10.2.2.4. ECDEV - 25/10/2021 - Lithgow Development Control Plan (Amendment 1) - Chapter 9 Pottery Estate Precinct

The purpose of this report is to inform Council of the outcomes of the public exhibition phase of Lithgow Development Control Plan Amendment 1 – Chapter 9 Pottery Estate Precinct. This report recommends that Council approves the amendment to Lithgow Development Control Plan 2021 (Chapter 9), as exhibited with minor amendments. It further recommends that final amendments and adoption authority be delegated to the General Manager to facilitate consideration of Heritage NSW review and comment in a timely manner.

ATTACHMENT 2: SUMMARY OF SUBMISSIONS – CHAPTER 9 POTTERY ESTATE DEVELOPMENT CONTROL PLAN (LITHGOW DEVELOPMENT CONTROL PLAN AMENDMENT 1)

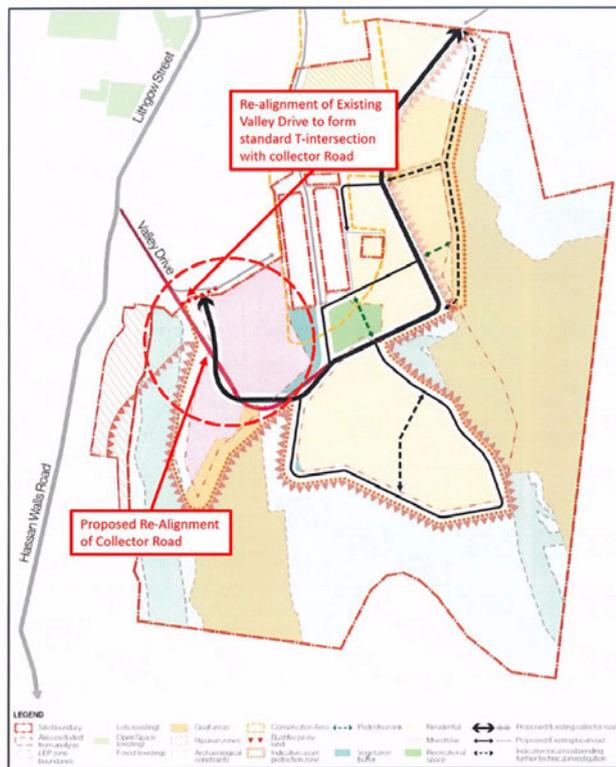
The structure plan identifies the collector road connecting from along the edge of the B4 Mixed use zone to Valley Drive at its point of curvature, directly opposite the western most carpark entry to the Pottery Estate Plaza.

At this location, Council is currently dealing with a past issue relating to the construction of Valley Drive outside the boundaries of the gazetted road reserve, affecting both private land and Council’s public reserve. A process is now underway to correct this issue by creating the required public road reserve to accommodate the existing constructed road alignment.

The indicative structure plan in Chapter 9 as exhibited shows the gazetted road reserve not the constructed alignment.

At the end of the exhibition period, a submission was received from PGH Environmental Planning acting on behalf of Project Innovations Pty Ltd/Ceedive Pty Ltd recommending an amendment to the southwestern and western alignment of the proposed Collector Road (affecting the area shown by red hatched circle in the Figure below) and its connection to Valley Drive within the Indicative Structure Plan.

The intent of the amendment is to create a more regular alignment that is responsive to the existing B4 zoning and to allow for regular subdivision pattern in the future. The amendments would have regard to the Valley Drive alignment as constructed and allows the creation of a standard T intersection as shown in solid red lines in the Figure below.

For Council to consider the realignment of any proposed new road as indicated in solid red lines in the Figure above the following matters would firstly need to be investigated and resolved:

Therefore, it is not recommended to alter the southwestern and western alignment of the collector road as identified the indicative structure plan at this time until the above matters are investigated and resolved. This is a separate process for Council consideration, and should Council be of a mind to explore this matter further it should be aware that the process can be complex and lengthy. If this were to be pursued at this juncture it would hold up the finalisation of the DCP for a considerable time. This matter should be the subject of a separate more detailed report to Council.

Figure 1 – Proposed Amendment to Collector Road Alignment

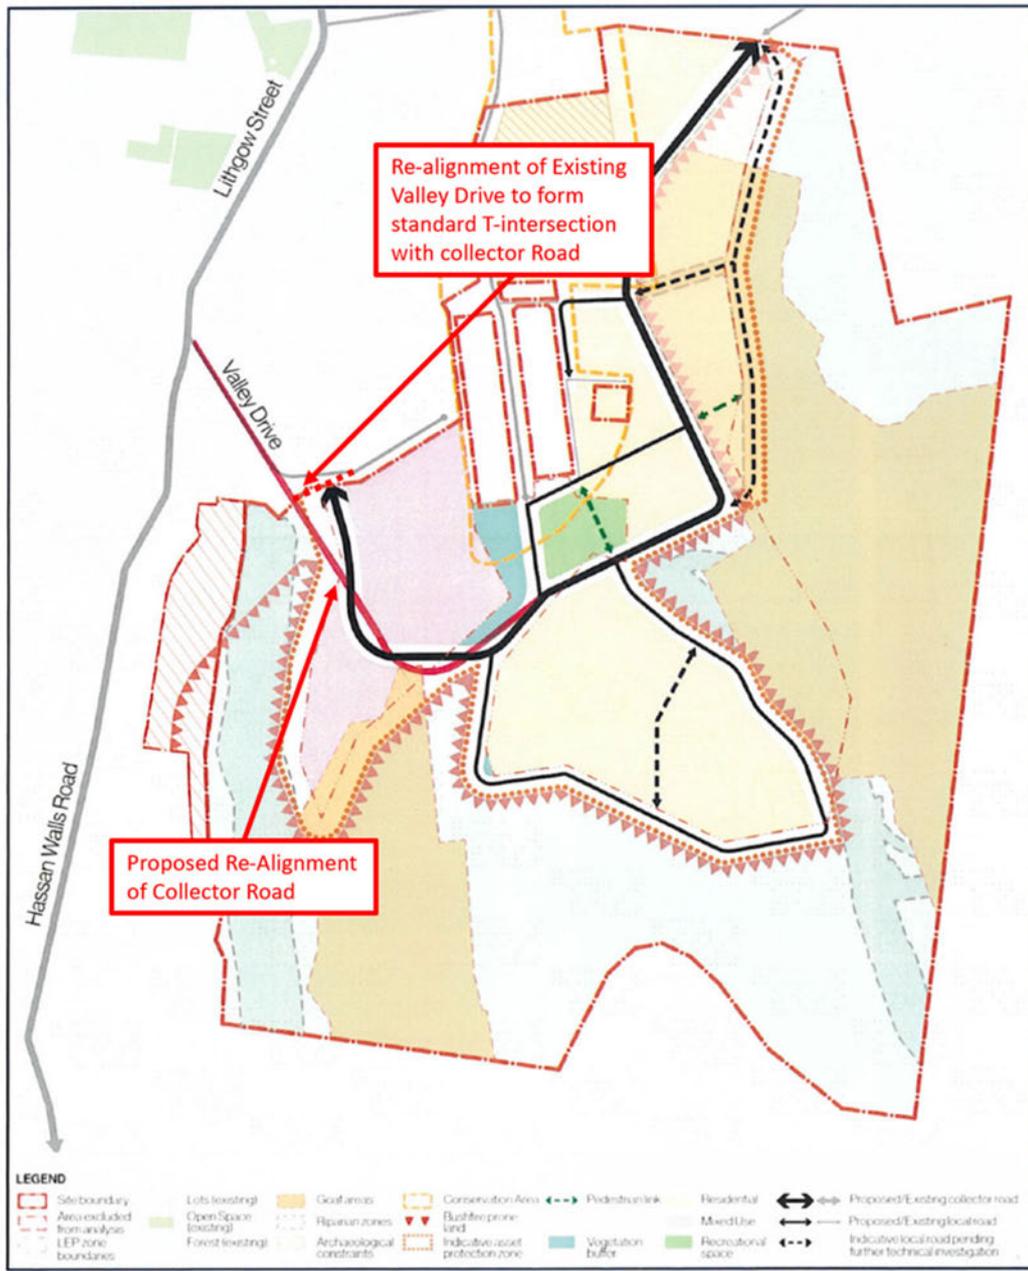
The proposed amendment to the Collector Road shown in the Indicative Structure Plan is shown in Figure 1.

As shown in Figure 1 the proposed re-alignment of the future 'collector road' combined with a realignment of Valley Drive will enable the formation of a standard T-intersection with the stem approach of the T-intersection meeting at 90 degrees to the straight approaches (top of the T).

The existing curved nature of Valley Drive (not represented clearly in the Indicative Structure Plan) would not facilitate an ideal road connection to the future collector road. The provision of a standard T-intersection would provide a safer road user outcome.

The straightening of the collector road alignment would also facilitate a more efficient lot layout for the mixed-use zone and any associated vehicle access driveways for mixed-use developments.

Figure 1 – Proposed Amendment to Collector Road Alignment

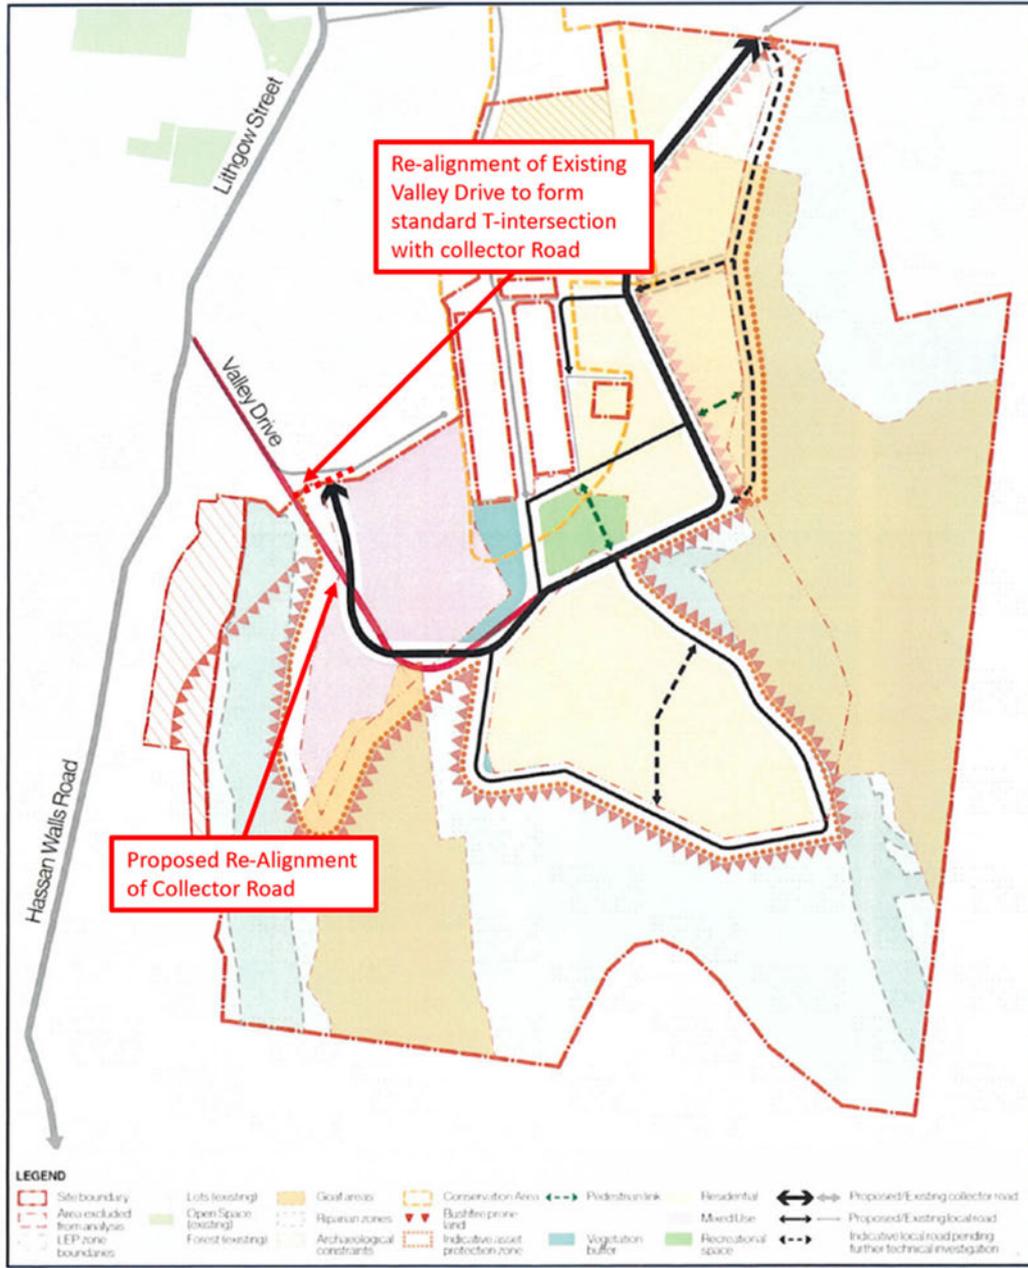
The proposed amendment to the Collector Road shown in the Indicative Structure Plan is shown in Figure 1.

As shown in Figure 1 the proposed re-alignment of the future 'collector road' combined with a realignment of Valley Drive will enable the formation of a standard T-intersection with the stem approach of the T-intersection meeting at 90 degrees to the straight approaches (top of the T).

The existing curved nature of Valley Drive (not represented clearly in the Indicative Structure Plan) would not facilitate an ideal road connection to the future collector road. The provision of a standard T-intersection would provide a safer road user outcome.

The straightening of the collector road alignment would also facilitate a more efficient lot layout for the mixed-use zone and any associated vehicle access driveways for mixed-use developments.
